Working Party on Passive Safety (GRSP)

PROPOSAL FOR DRAFT AMENDMENTS TO REGULATION No. 14
(Safety-belt anchorage)

Transmitted by the Expert from Spain

Fig 1: rigid buckle, articulated

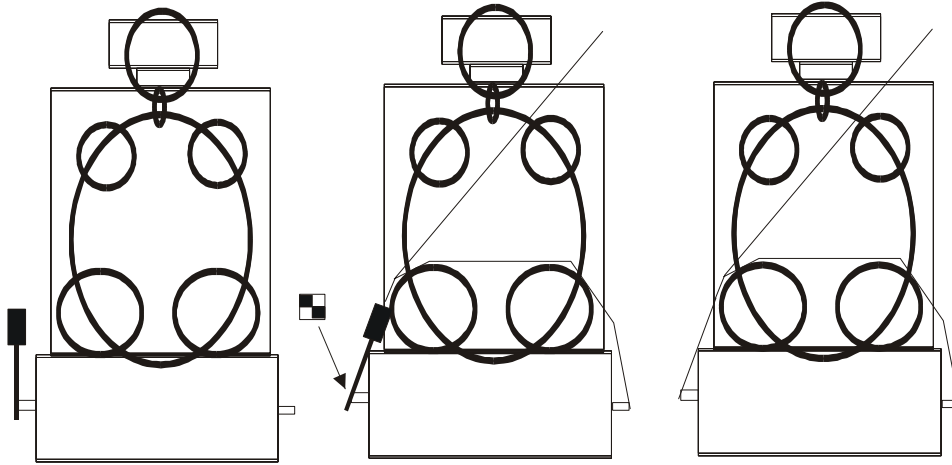
Fig 1.1: when we change the rigid buckle by a strap, contact areas between dummy and belt remain unchanged

Proposal: pivoting point should be the effective anchorage

Fig 2; rigid buckle fixed

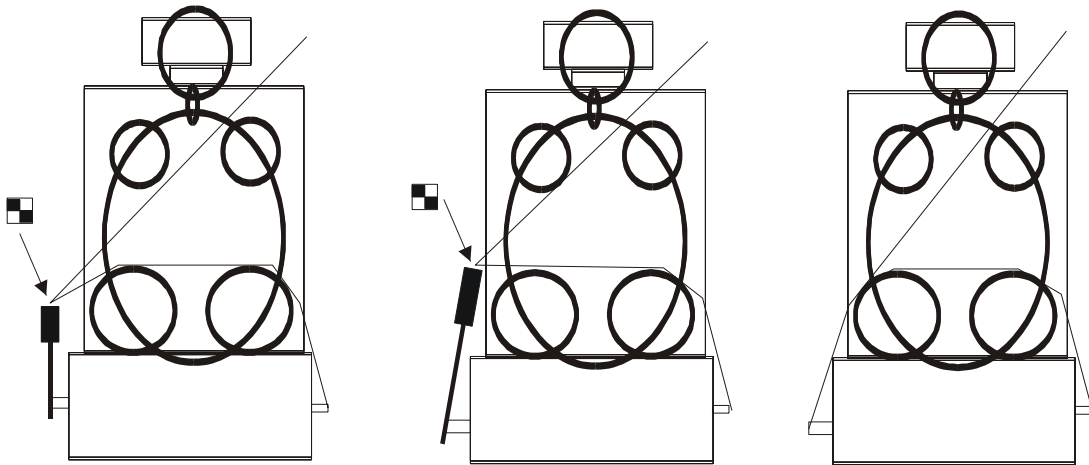
Fig 3; articulated buckle; but when we change it by a strap, contact areas are changed too; effective anchorage is not the pivoting point.
